DOCKETED	
Docket Number:	24-OPT-03
Project Title:	Soda Mountain Solar
TN #:	261667
Document Title:	Appendix AA_Determination of Infeasibility for DR BIO-20
Description:	Appendix AA provides a determination of infeasibility for CEC Data Request BIO-20, which requested an assessment of the feasibility of a 0.25-mile buffer from areas with 10% slope.
Filer:	Hannah Arkin
Organization:	Resolution Environmental
Submitter Role:	Applicant Consultant
Submission Date:	2/9/2025 8:10:48 PM
Docketed Date:	2/10/2025

SUBJECT: DETERMINATION OF INFEASIBILITY FOR CEC DATA REQUEST BIO-20, SODA MOUNTAIN SOLAR PROJECT (24-OPT-03)

Figure 1. 0.25 mile buffer from 10% slope

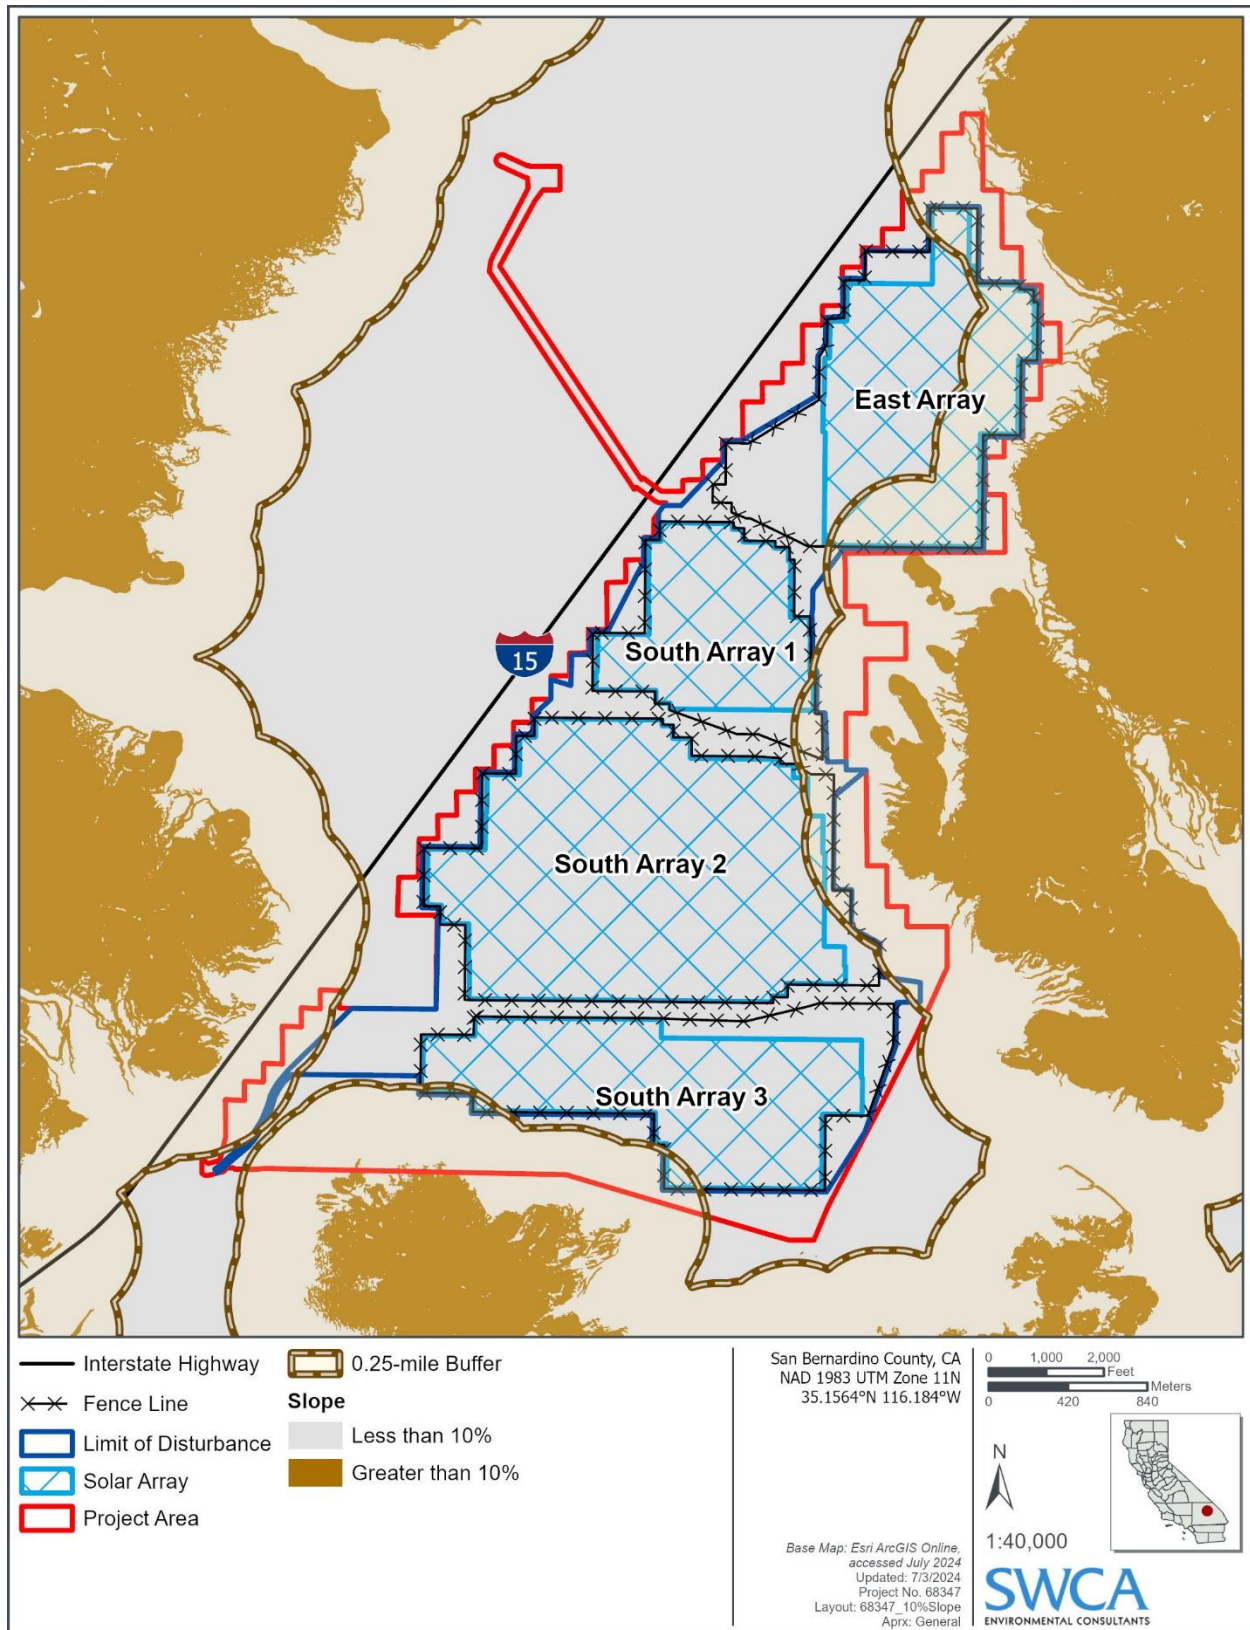
DR BIO-20 requests an assessment of feasibility of a 0.25-mile buffer from areas with 10% slope to address potential impacts to desert bighorn sheep (*Ovis canadensis nelsoni*). This request is based upon information contained within Opt-In Application (24-OPT-03) Appendix D2 Desert Bighorn Sheep Study (TN 257948), which was completed by the California Department of Fish and Wildlife (CDFW). Implementation of a 0.25-mile buffer would result in a project footprint reduction of 236 acres, or approximately 12% of the project footprint, when compared to the proposed project submitted in the Opt-In Application for the Soda Mountain Solar Project (24-OPT-03). Please see Table 1 and Figure 1.

Implementation of a 0.25-mile buffer from areas with 10% slope would reduce the project's 300 MW solar energy generation capacity and 300 MW battery energy storage capacity by at least 12%. It is important to note that the reduction in project footprint size due to implementation of a 0.25-mile buffer may not result in a linear reduction in the project's energy generation and storage capacity. In other words, a 12% reduction in the project footprint could result in a reduction in the project's energy generation and storage capacity of much greater than 12%. This is because the project contains civil design features such as roads, fences, and basins, and moving these project components would lead to an even greater reduction to the solar field and BESS size than the 236-acre reduction from buffer implementation.
